ISSUE 29 - APR-MAY-JUN 90

SECTION 3 - AMIGA

-
- 29/3-0.0 INDEX - AMIGA SECTION TECHTOPICS ISSUE 29.
 - 29/3-1.1 A2091 MEMORY AUTO-CONFIGURATION LIMITATIONS.
 - 29/3-2.1 A2091 IC MEMORY 262,144 ADDRESS X 4 BIT DRAM.

DIAGRAM 25/3-3.2

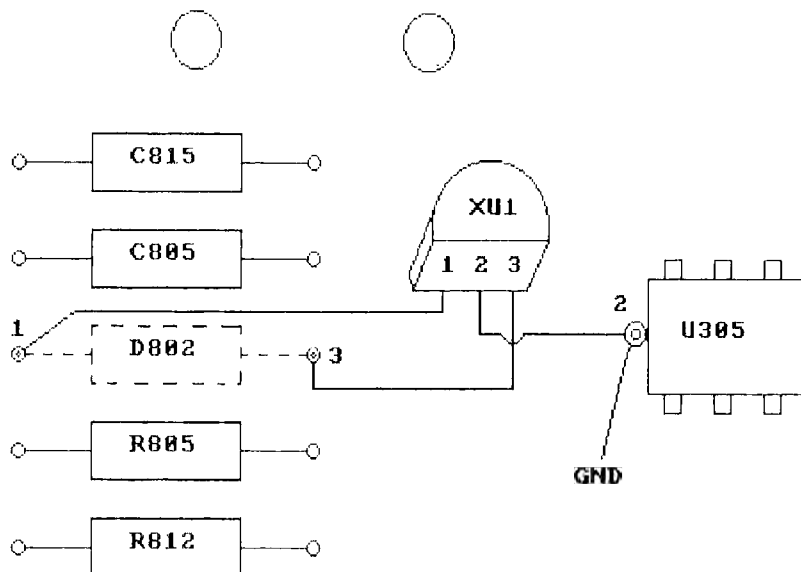
LOCATE U305 (TO THE LEFT OF CN303, 34 PIN DRIVE CABLE).
LOCATE D802 (DOWN, TO THE RIGHT OF U305).
INSTALL PST518B (DESIGNATED XU1) USING INSULATION TUBING AS REQUIRED TO PREVENT THE POSSIBILITY OF SHORTS.

SOLDER PIN 1 OF XU1 TO +5 VOLT SIDE OF DIODE D802.
SOLDER PIN 2 OF XU1 TO GND, USE PLATED HOLE AT THE BASE OF IC U305.
SOLDER PIN 3 OF XU1 TO THE ANODE SIDE OF DIODE D802.

A2000 SYSTEM CLOCK FIX DIAGRAM

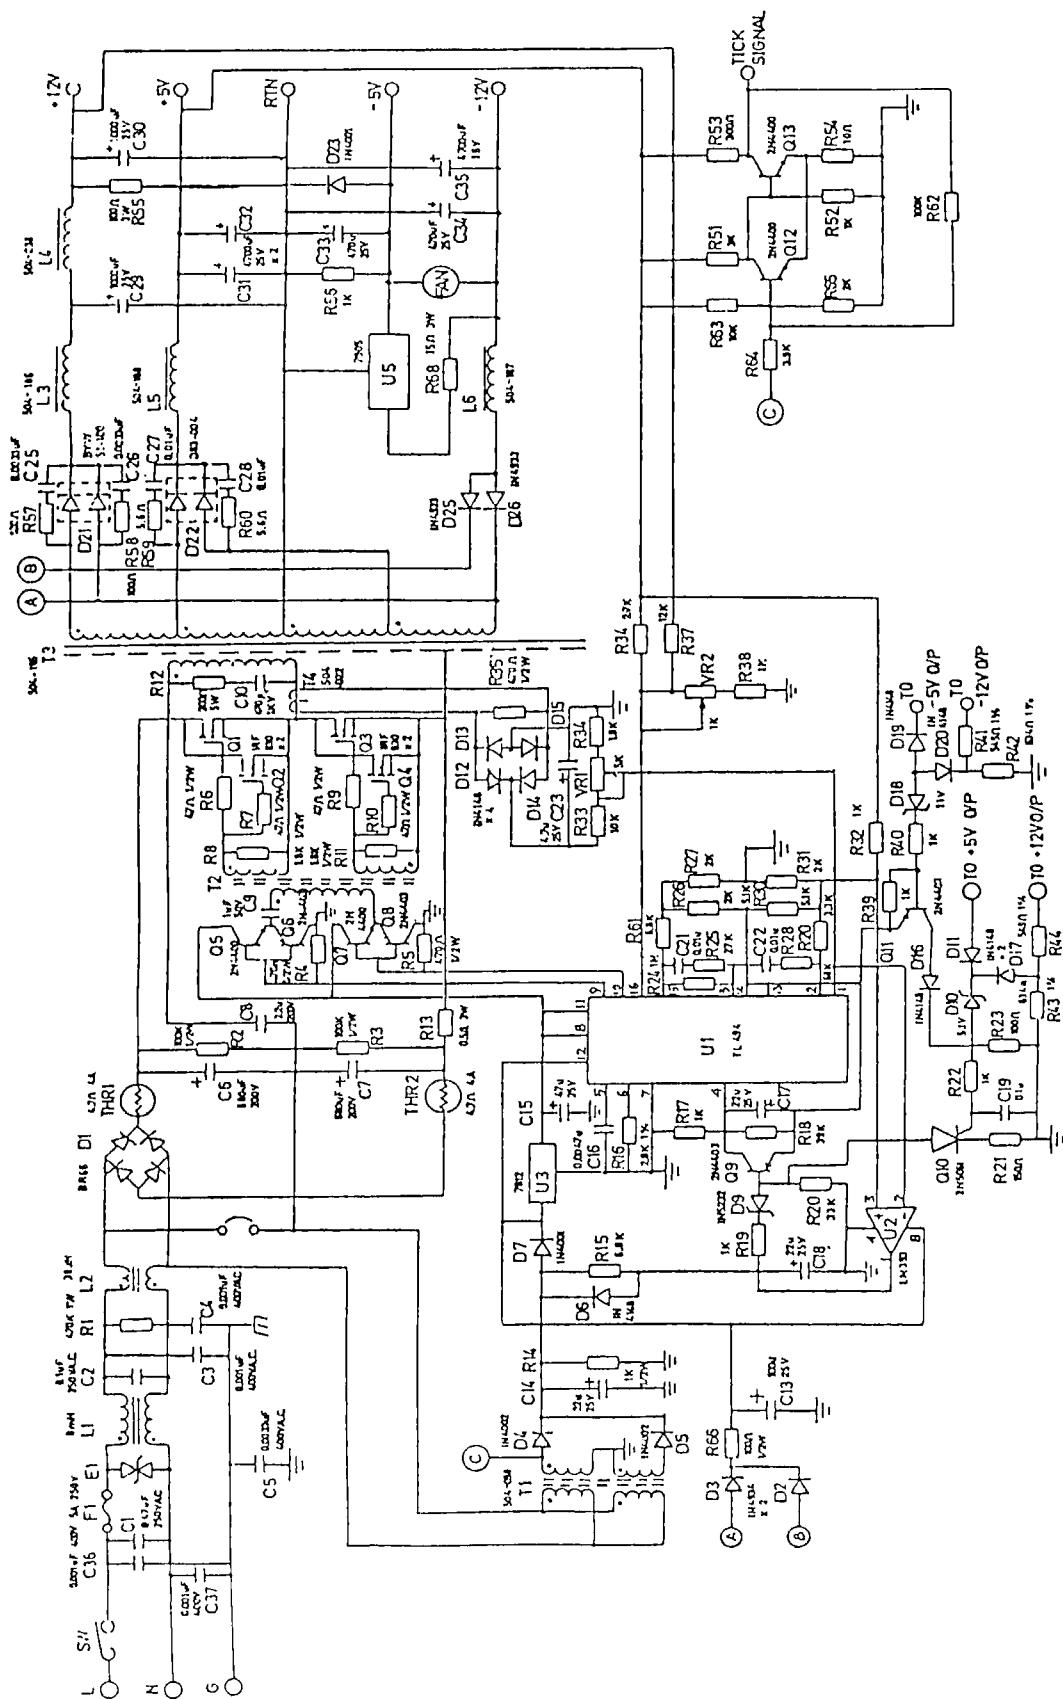
A WARRANTY LABOR RATE OF \$20.00 WILL BE CREDITED FOR THE FOLLOWING FIX ON THE ELTEK TYPE POWER SUPPLY TO CORRECT NOISE ON TICK SIGNAL. NOTE, A WHITE '00' STICKER IS ON POWER SUPPLIES WHICH HAVE THE MODIFICATION INSTALLED.

REFER TO ATTACHEMENT, ELTEK POWER SUPPLY SCHEMATIC. CHECK PIN 14 (TICK SIGNAL) OF CN400 WITH SCOPE FOR NOISE. ADD, ON POWER SUPPLY, 0.01 UF CAPACITOR BETWEEN R65 (GND SIDE), AND R62, AS INDICATED IN DETAIL DIAGRAM BELOW.

DIAGRAM - A

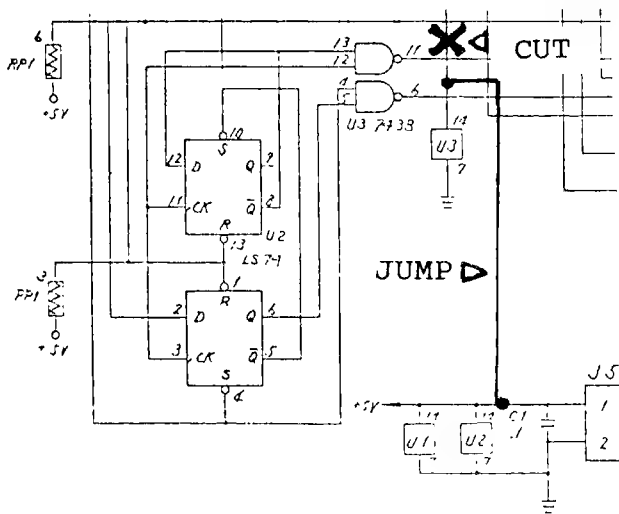
THE FOLLOWING MODIFICATION TO THE A1020 IS REQUIRED FOR OPERATIONS WITH THE A500. A WARRANTY LABOR RATE OF \$20.00 WILL BE CREDITED FOR THIS FIX ON DRIVES WITHIN THE COMMODORES NORMAL 90 DAY WARRANTY. UNITS OUTSIDE OF WARRANTY PERIOD WILL NOT RECIEVE CREDIT.
